RE: Drinking Water and Pressure Irrigation Master Plan – Review of amendments to the Bluffdale

Water Master Plan I and II.

SUBJECT: East Side Water Planning Recommendations

PROJECT NO.: 394.02.100

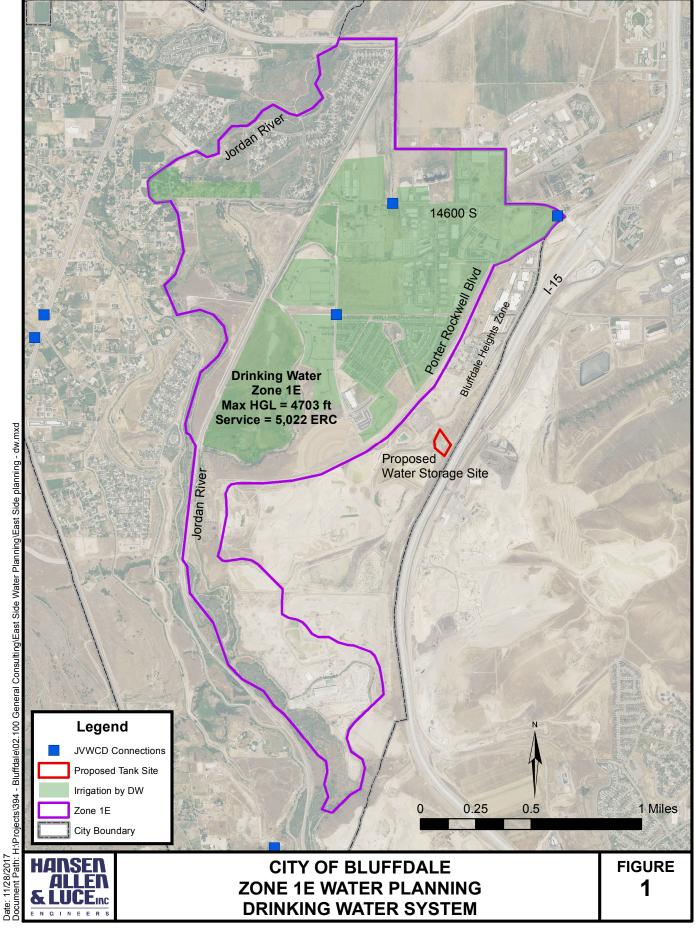
- 1. Zone 1E to be mostly independent of Zone 1W; only east—west DW connection is through 14600 S. No PI connection is planned between Zones 1E and 1W.
- 2. Water storage to be situated on Geneva Rock property as shown in Figure 1.
- 3. DW tank to have maximum hydraulic grade line (HGL) of 4703 ft. This will always allow the tank to be filled by gravity from the Jordan Valley Water Treatment Plant (max. HGL = 4724 according to Dave McLean's email on Aug. 8, 2017). Site constraints will not allow the tank to be situated much higher.
- 4. PI pond to have maximum HGL of 4690 ft based on site constraints (elevation) and sufficient head difference to prevent backflow into the DW system under normal operating conditions.

Since high-density and mixed-use developments will constitute a significant portion of developable land in Zone 1E (Figure 1) and will not have PI service, their indoor and outdoor demands were evaluated from historical drinking water billing data. The data were provided on Nov. 8, 2017, and contain monthly records for 359 connections. Average demand is 324 gpd/conn. Peak-month demand is 611 gpd/conn, of which HAL attributed 148 gpd/conn to indoor demands (based on wintertime use) and the remaining 463 gpd/conn to outdoor use. Since the observed average and peak-month demands for these smaller housing units are less than required for a typical ERC even when considering outdoor demands, each such connection is assumed to be 1 ERC for planning purposes and no additional outdoor demand is assumed.

Based on the foregoing results, HAL recommends that the City begin financial planning and preliminary engineering for a 3.0 MG drinking water tank and 16 in. diameter transmission pipeline, and a 1.0 MG (3.1 ac-ft) pressurized irrigation pond and 12 in. diameter transmission pipeline. These facilities will serve Zone 1E through buildout.
